Langtree PP and Panattoni

Six 56 Warrington

Addendum to Environmental Statement

Part 2 – Noise and Vibration Technical Paper 7

Figure 7.2a: Extent of bund and acoustic barrier mitigation measures – 2D Plan

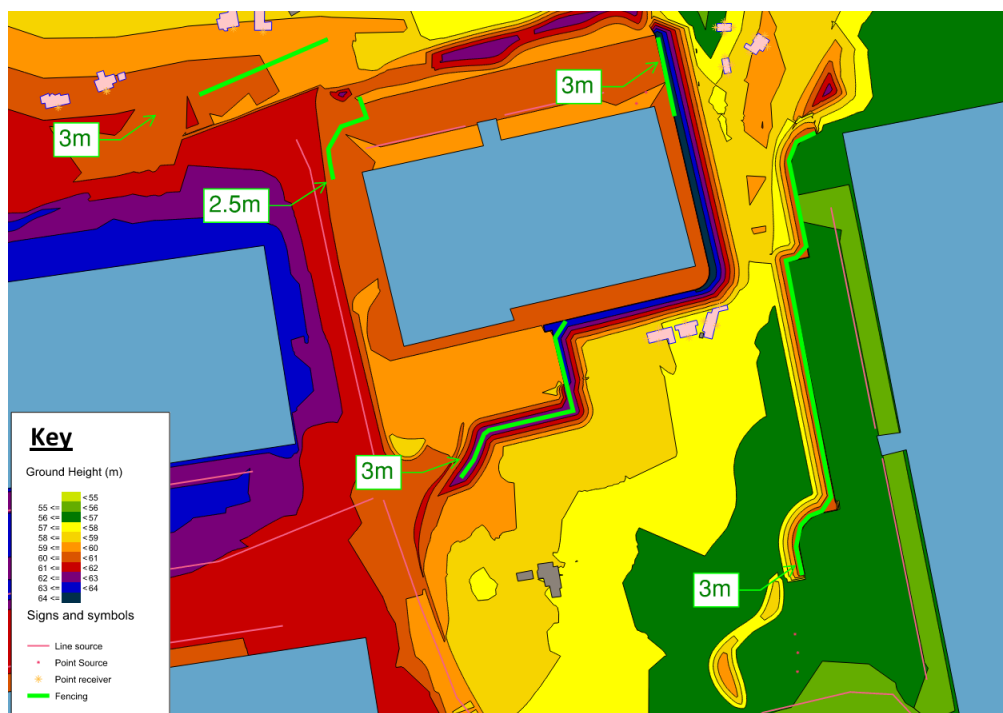
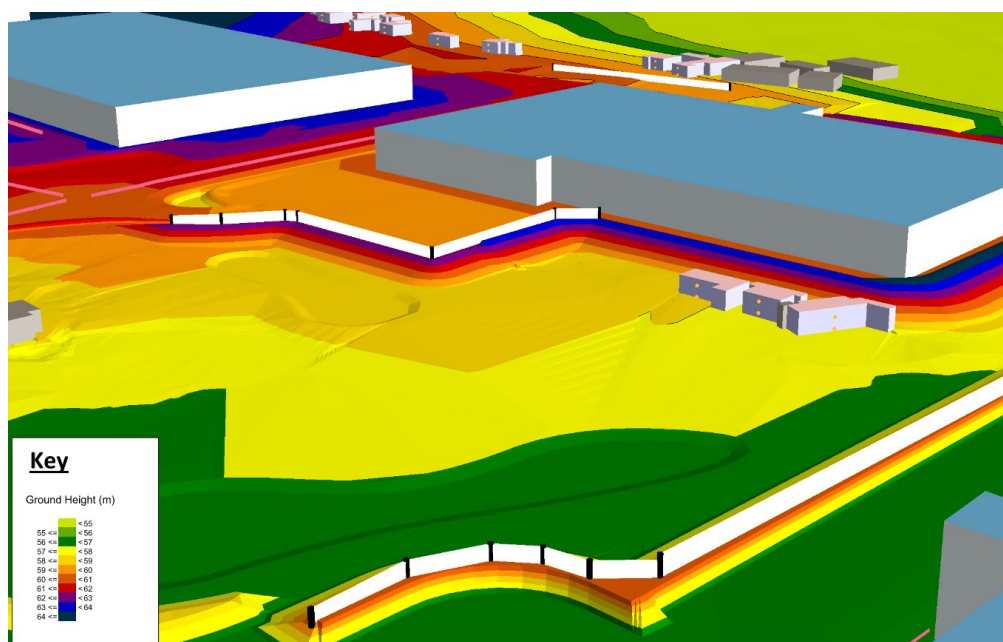
- 3m Fence on the bund peak to the south of Plot 1 - west of Bradley Hall Cottages
 - 3m Fence the bund peak to the west of Plot 2 - east of Bradley Hall Cottages

- 7.56. The figures below show a clipped excerpt from Appendix 7.3 as well as a 3D view of proposed timber fencing.
